# ***Village of Lemont***

## **PLANNING AND ZONING COMMISSION**

**March 4, 2020 – 6:30 PM**

**TO:** Planning & Zoning Commission  
**FROM:** Jamie Tate, AICP, Consulting Planner  
**THRU:** Mark Herman, MPA, AICP, Community Development Manager

# FINAL PLAT OF PAWL SUBDIVISION

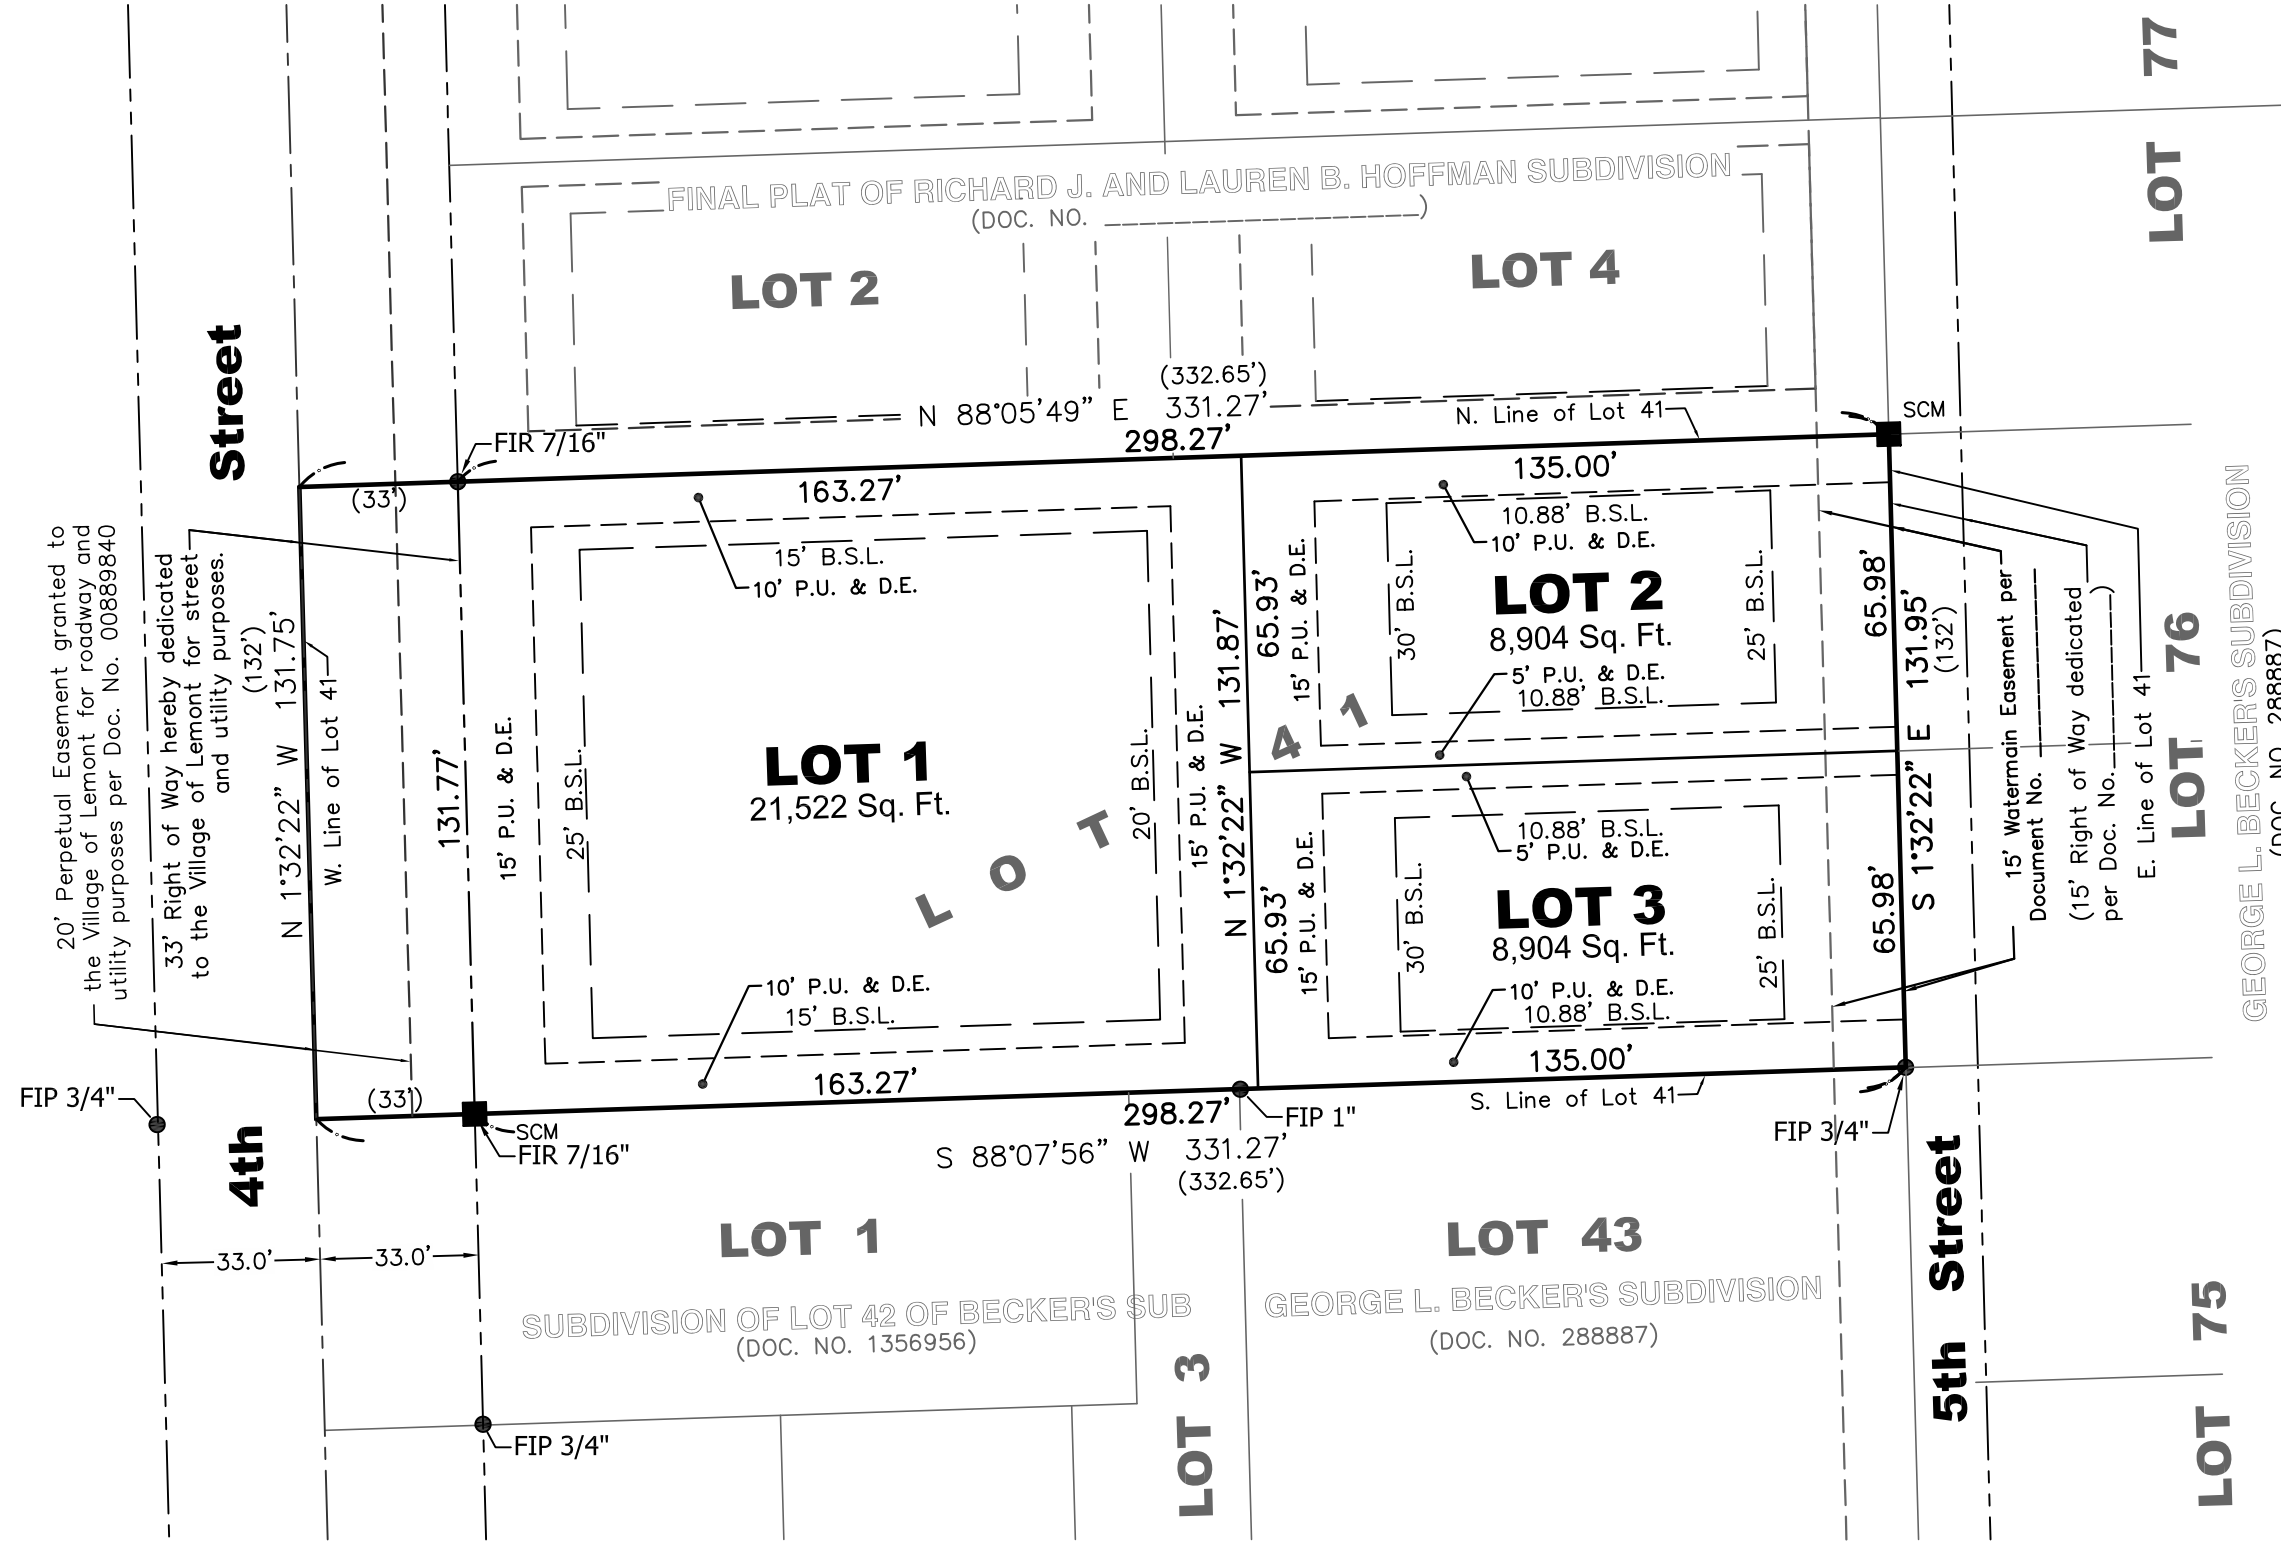
7. The Final Plat references the proposal being both the Resubdivision of Lot 41 and in the Legal Description it references Lot 410. Clarify and adjust accordingly.
